Contract #: 04-0120F4
 Cty: SF/ALA Rte: 80 PM: 13.2/13.9
 File #: 69.25B

QUALITY ASSURANCE -- NON-CONFORMANCE REPORT

Report No: NCR-000638

Reference Description: ZPMC placed 9.7 tons weight on Tower Strut web for the purpose of straightening

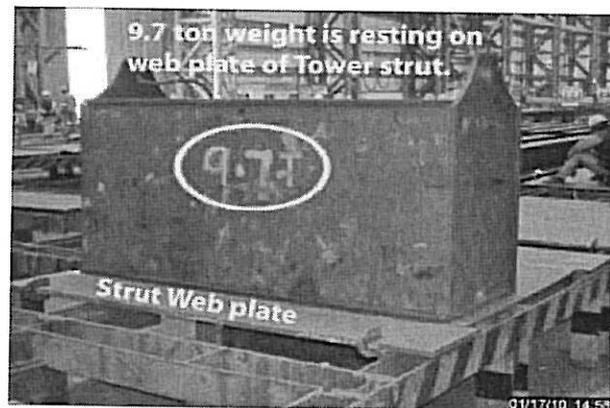
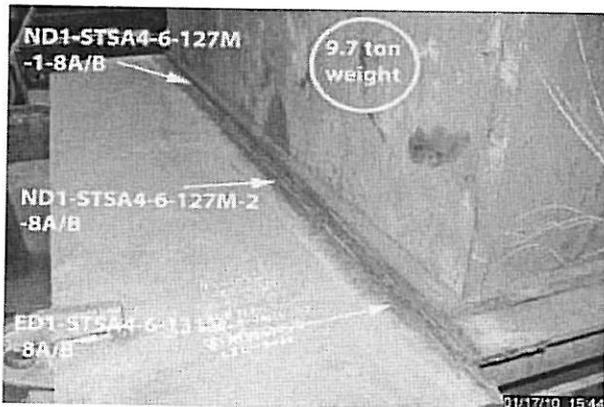
During the random Quality Assurance(QA) in process verification of Tower Strut plate, this QA Inspector observed the following issues:

- ZPMC placed a 9.7 ton weight on a 16mm thick Tower Strut web for the purpose of straightening.
- ZPMC CWI Yu Dong Ping referenced heat straightening document HSR1 (T)-11020 Rev. 0 as being the controlling document.
- The referenced document does not indicate any weight and/or mechanical force being used for straightening.
- 65 degree "Tempilstick" did not melt when applied to material.
- The weld numbers are identified as ED1-STSA4-6-131-1-7A/B, 8A/B; ND1-STSA4-6-127M-1-7A/B, 8A/B; ND1-STSA4-6-127M-2-7A/B, 8A/B.
- The material is designated as Seismic Performance Critical Member (SPCM).
- The member is located at Tower Bay No. 11.

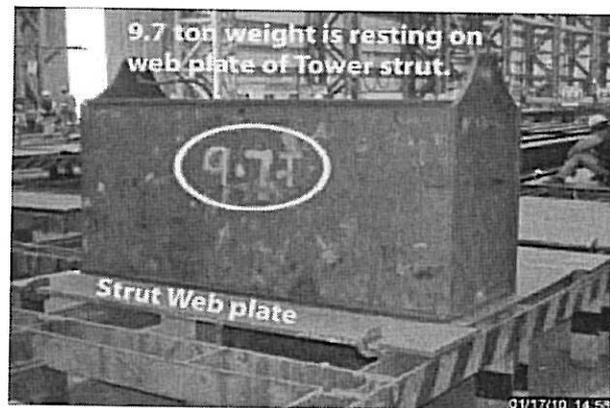
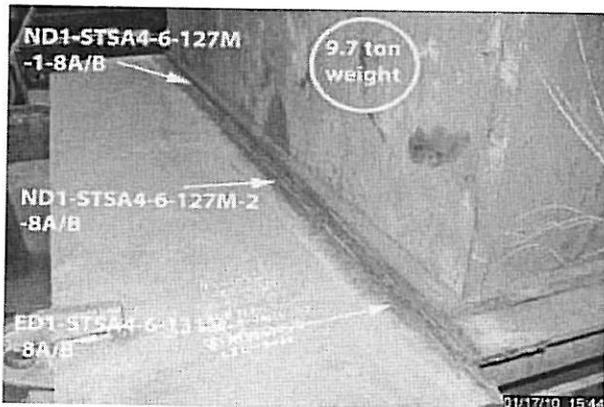
During the random Quality Assurance(QA) in process verification of Tower Strut plate, this QA Inspector observed the following issues:

- ZPMC placed a 9.7 ton weight on a 16mm thick Tower Strut web for the purpose of straightening.
- ZPMC CWI Yu Dong Ping referenced heat straightening document HSR1 (T)-11020 Rev. 0 as being the controlling document.
- The referenced document does not indicate any weight and/or mechanical force being used for straightening.
- 65 degree "Tempilstick" did not melt when applied to material.
- The weld numbers are identified as ED1-STSA4-6-131-1-7A/B, 8A/B; ND1-STSA4-6-127M-1-7A/B, 8A/B; ND1-STSA4-6-127M-2-7A/B, 8A/B.
- The material is designated as Seismic Performance Critical Member (SPCM).
- The member is located at Tower Bay No. 11.
